ADA ACCESSIBILITY REPORT

The Fauquier County Board of Supervisors

Fauquier County, Virginia

SAMAHA ASSOCIATES, P.C.

FIRST FLOOR

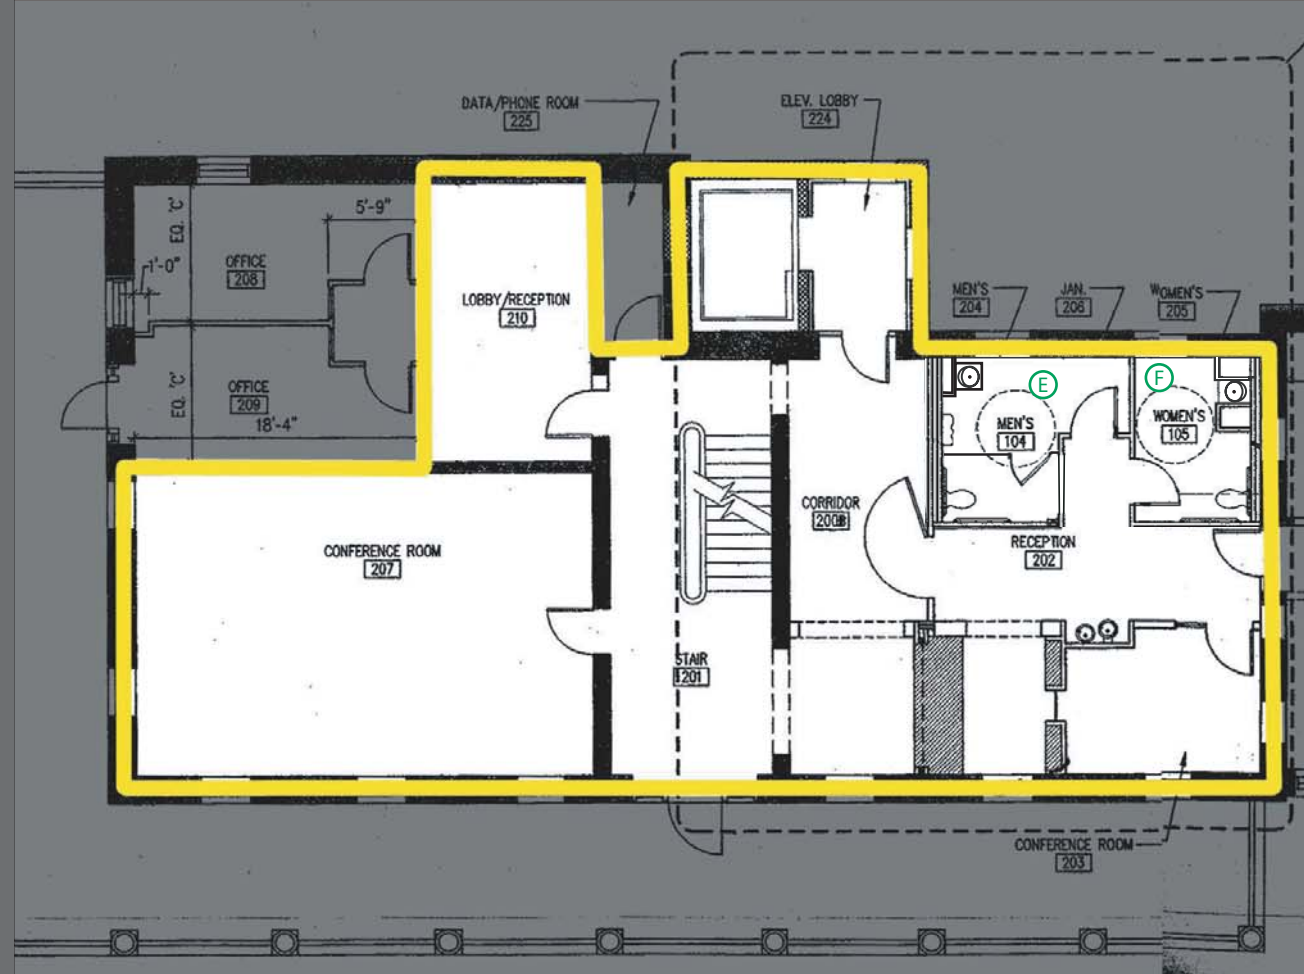
| Plan Symbol | Item | ADAAG Reference | ANSI- A117.1- 2003 Reference | Requirement | Required Effort to Comply with the ADA | Budget Estimate |
|-------------------|---|--------------------------------|---------------------------------------|---|---|-----------------|
| A | 76" Clear Head Height at Stair | 4.3.5 Not Req'd per 4.16(d) | IBC | Headroom: Min. clear headroom: 80". "...if the elevators and stairs in a building are being altered and the elevators are, in turn, being made accessible, then no accessibility modifications are required connecting levels connected by the elevator." | Not Required by the ADA | \$ - |
| B | Reduced Clear Height under Stair | 4.4.2 | 307.4 | If vertical clearance of an area adjoining an accessible route is reduced to less than 80", a barrier shall be provided. Reduced Vertical Clearance: Guardrails or other barriers shall be provided where object protrusion is beyond the limits allowed by Sections 307.2 and 307.3 and where the vertical clearance is less than 80" above the floor. The leading edge of such guardrail or barrier shall be 27" max. above the floor. | Add railing or fixed furniture below the area of low clearance. | \$ 1,000.00 |
| C | Double 28" Wide Entry Doors | 4.13.4 | 404.2.2 | Double Leaf Doorways: If doorways have two idependently operated door leaves, then at least one leaf shall be accessible. That leaf shall be an active leaf. At least one of the active leaves of the doorways with two leaves shall comply with Sections 404.2.2 and 404.2.3. | Provide automatic door operator or replace doors | \$ 2,000.00 |
| D | Inaccessible Platform | 4.3.8 | 303.3 | Changes in level greater than 1/2" requires a ramp, elevator or platform lift. Changes in level greater than 1/2" in height shall be ramped and shall comply with Section 405 or 406 | Provide accessible ramp. | \$ 2,500.00 |
| E | Inaccessible Manuevering Clearances at Doorway | 4.13.6 | Table 404.2.3.1 | Latch side approach to pull side, if door has a closer: 24" beyond latch side of door, 54" perpendicular to doorway. Maneuving Clearances at Manual Swing Doors: For latch side approach from pull side, 24" parallel to doorway beyond latch side of door, 48" perpendicular to doorway (54" perpendicular required with closer). | Relocate interior partitions and replace door and frame to accommodate required clearances. (2) locations | \$ 8,000.00 |

SECOND FLOOR

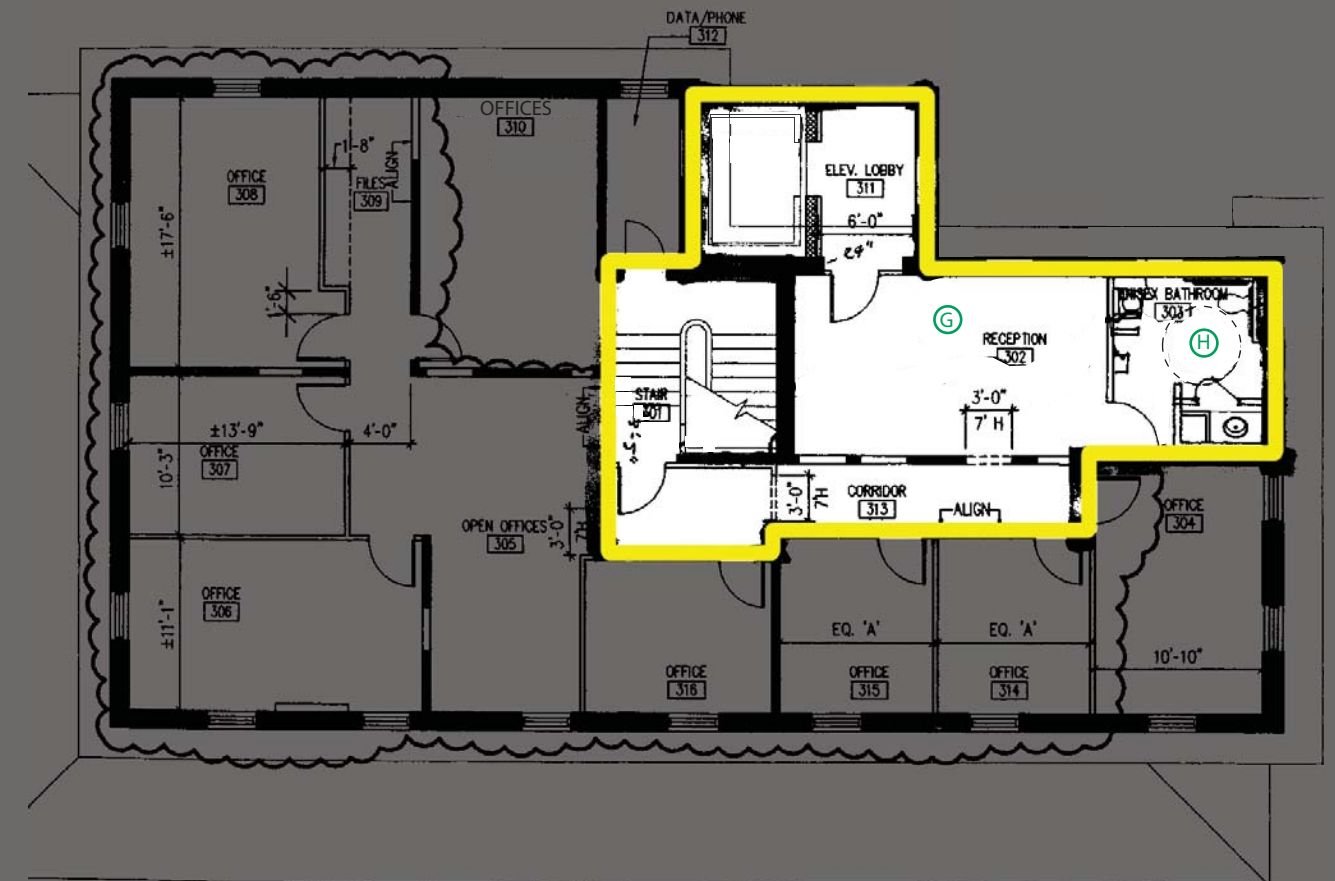
| F | 9" Protruding Depth at Paper Towel Dispenser | 4.4.1 | 307.2 | Protruding Objects. Objects projecting from walls with their leading edges between 27" & 80" above the finished floor shall protrude no more than 4" into walks, halls, corridors passageways or aisles. Protusion Limits: Objects with leading edges more than 27" and not more than 80" above the floor shall protrude 4" max. horizontally into the circulation path. | Replace Paper Towel Dispenser with ADA accessible model surface mounted or recessed model. (2) | \$ 2,000.00 |
| G | Non-Compliant Service Counter | 7.2 | 904.3.1 | A portion of the main counter, minimum 36" in length, maximum of 36" above the floor, shall be provided. Parallel Approach. A portion of the counter surface 36" min. in length and 36" max. in height above the floor shall be provided. | Provide compliant height service counter | \$ 500.00 |
| H | 24" Rear Wall Grab Bar | 4.16.4 | 604.5.2 | For water closets not located in toilet stalls, the following grab bars shall be provided, 33" - 36" above the finish floor: Back Wall: 36" long min., 12" each side of water closet centerline. Rear Wall Grab Bars: The rear wall grab bar shall be 36" min. in length, and extend from the centerline of the water closet 12" min. on the side closest to the wall, and 24" min. on the transfer side. | Renovate area to accommodate installation of 36" grab bar. | \$ 250.00 |

UPPER LEVEL

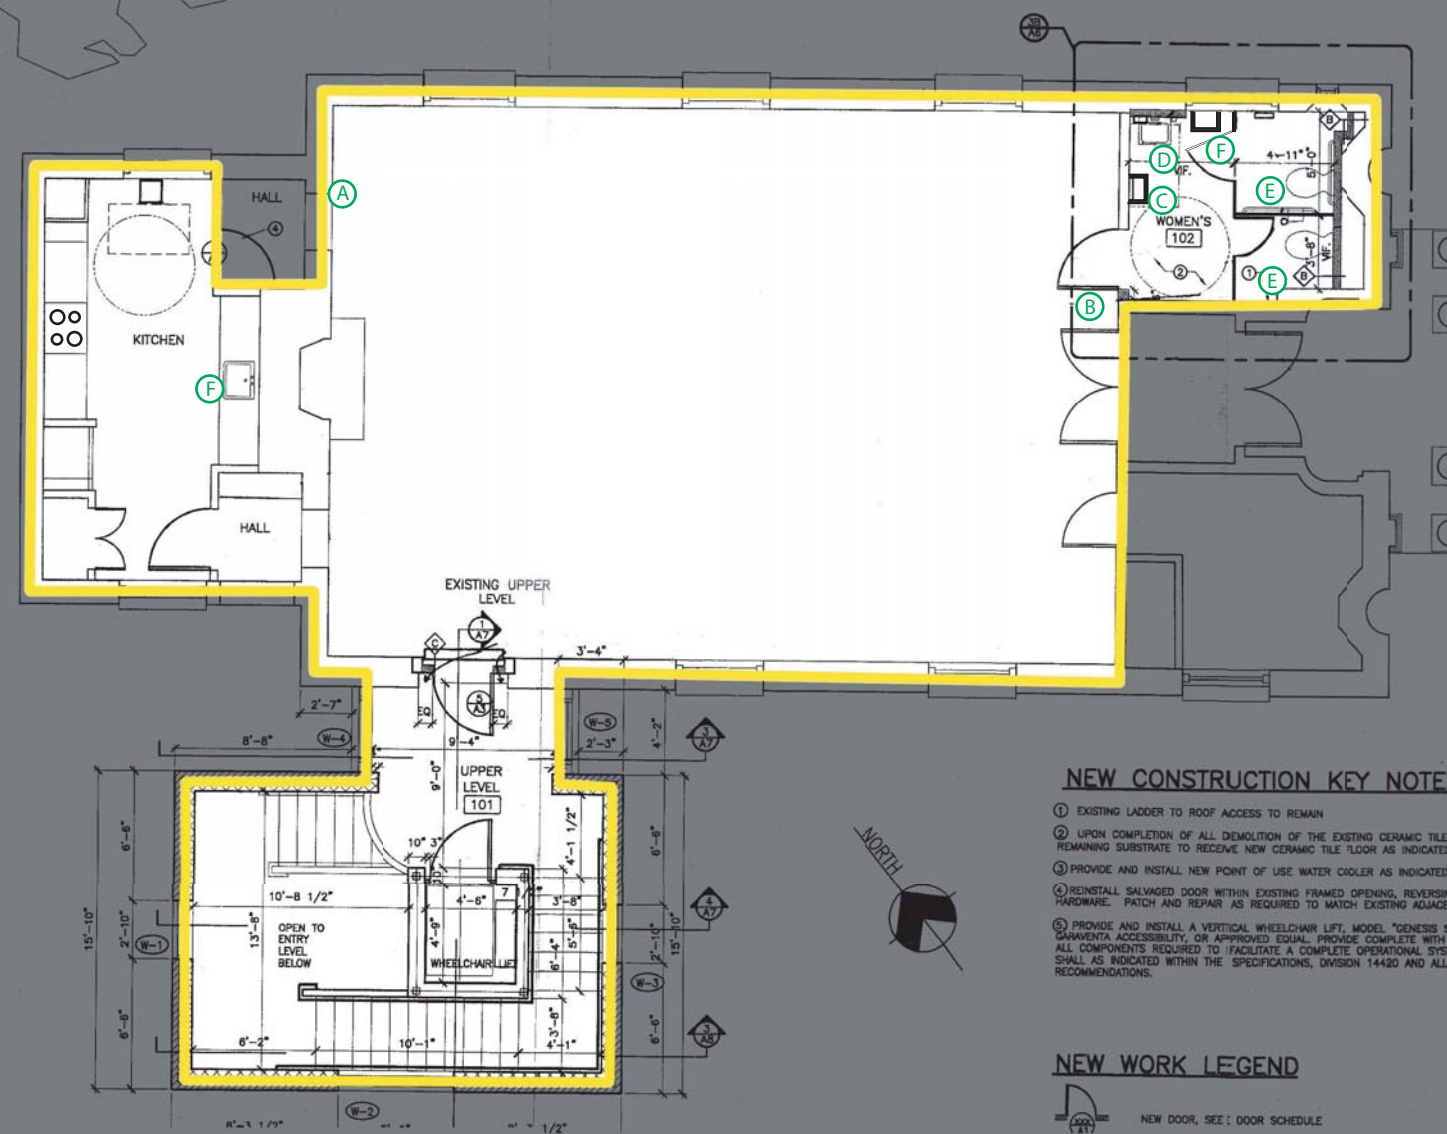
| Plan Symbol | Item | ADAAG Reference | ANSI- A117.1- 2003 Reference | Requirement | Required Effort to Comply with the ADA | Budget Estimate |
|---------------------------------|---|--------------------|---------------------------------------|--|---|-----------------|
| A | 77" Head Height at Framed Opening | 4.3.5 | 404.2.2 | Headroom: Min. clear headroom: 80". Projections into the clear opening width between 34" and 80" above the floor shall not exceed 4". | Reconstruct framed opening to increase clear head height. | \$ 500.00 |
| B | Signage Mounted to Face of Swinging Door | 4.30.6 | 703.3.11 | Where permanent identification is provided for rooms and spaces, signs shall be instlled on the wall adjacent to the latch side of the door. Location: Where a tactile sign is provided at a door, the sign shall be alongside the door at the latch side. | Relocate interior signage per code requirements. | \$ 50.00 |
| C | 10" Protruding Depth at Paper Towel Dispenser | 4.4.1 | 307.2 | Protruding Objects. Objects projecting from walls with their leading edges between 27" & 80" above the finished floor shall protrude no more than 4" into walks, halls, corridors passageways or aisles. Protusion Limits: Objects with leading edges more than 27" and not more than 80" above the floor shall protrude 4" max. horizontally into the circulation path. | Replace Paper Towel Dispenser with ADA accessible model surface mounted or recessed model. | \$ 1,000.00 |
| D | Reduced Clear Floor Space at Lavatory | 4.24.5 | 606.2 | A clear floor space 30" x 48" shall be provided in front of a sink to allow forward approach. A clear floor space complying with Section 305.3, positioned for forward approach shall be provided. | Relocate sink to accommodate clear floor area required. | \$ 1,000.00 |
| E | Toilet Paper Dispenser Mounted at 44" Height | 4.16.6 | Not Req'd | Toilet paper dispensers shall be installed on the side wall, below the grab bar, a minimum 19" above the floor, and a maximum 36" from the rear wall. | Provide accessible accessory installed in a compliant location. (2) | \$ 250.00 |
| F | P.T. Dispenser Restricts 90 Degree Opening of Toilet Partition Door | 4.13.5 | 404.2.2 | Doorways shall provide a clear opening of 32" min., with the door open 90 degrees. Clear opening width of doorways with swinging doors shall be measured between the face of the door and stop, with the door open 90 degrees. | Replace Paper Towel Dispenser with ADA accessible model surface mounted or recessed model. | \$ 1,000.00 |

LOWER LEVEL

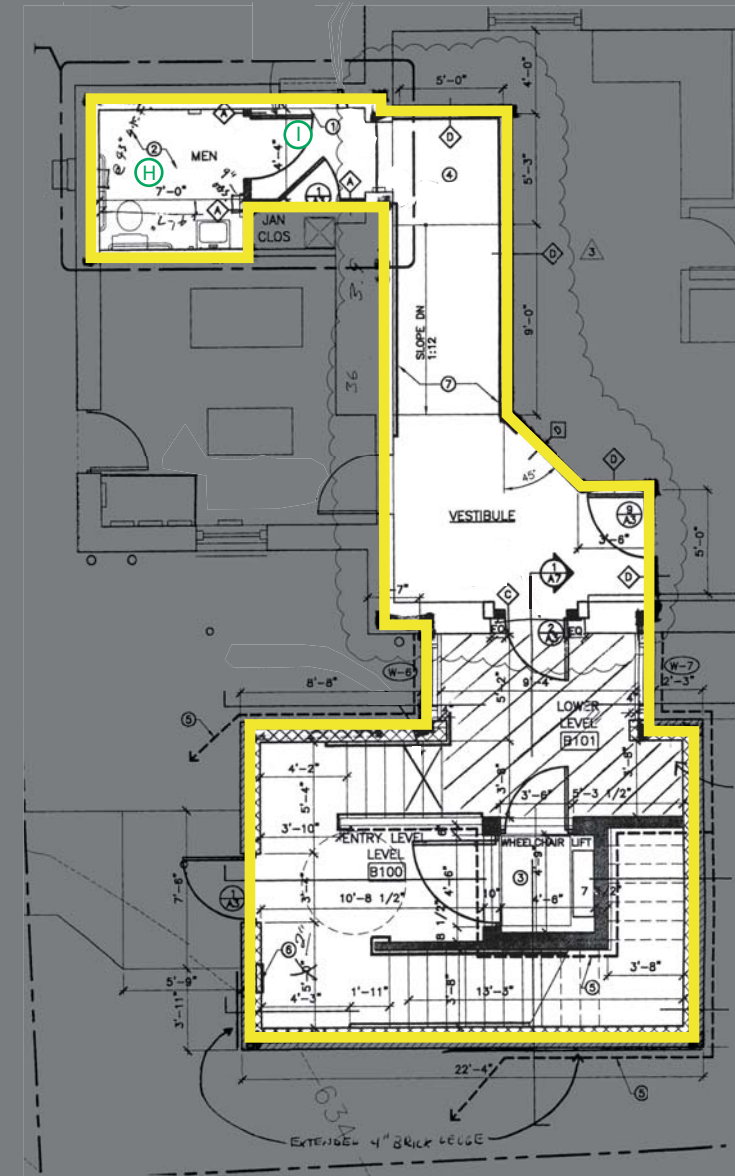
| Plan Symbol | Item | ADAAG Reference | ANSI- A117.1- 2003 Reference | Requirement | Required Effort to Comply with the ADA | Budget Estimate |
|---------------------------------|---|--------------------|---------------------------------------|--|---|-----------------|
| G | Inaccessible Sink in a Space Including a Range | 4.24.1 | 606.2 | If sinks are provided, then at least one shall comply with this section. A clear floor space complying with Section 305.3, positioned for a forward approach, shall be provided. Knee and toe clearance complying with Section 306 shall be provided. Exceptions: A parallel approach complying with Section 305 shall be permitted to a kitchen sink where a cook top or conventional range is not provided. | Convert sink base cabinet and replace sink to allow knee clearance and forward approach. | \$ 2,000.00 |
| H | Lavatory Overlap at Toilet Clear Floor Area | Not Req'd | 604.3.2 | Overlap: The required clearance around the water closet shall be permitted to overlap the water closet, associated grab bars, paper dispensers, sanitary napkin receptacles, coat hooks, shelves, accessible routes, clear floor areas at other fixtures and the turning space. No other fixtures or obstructions shall be within the required water closet clearance. | Not Required by the ADA | \$ - |
| I | Signage Mounted to Face of Swinging Door | 4.30.6 | 703.3.11 | Where permanent identification is provided for rooms and spaces, signs shall be instlled on the wall adjacent to the latch side of the door. Location: Where a tactile sign is provided at a door, the sign shall be alongside the door at the latch side. | Relocate interior signage per code requirements. | \$ 50.00 |
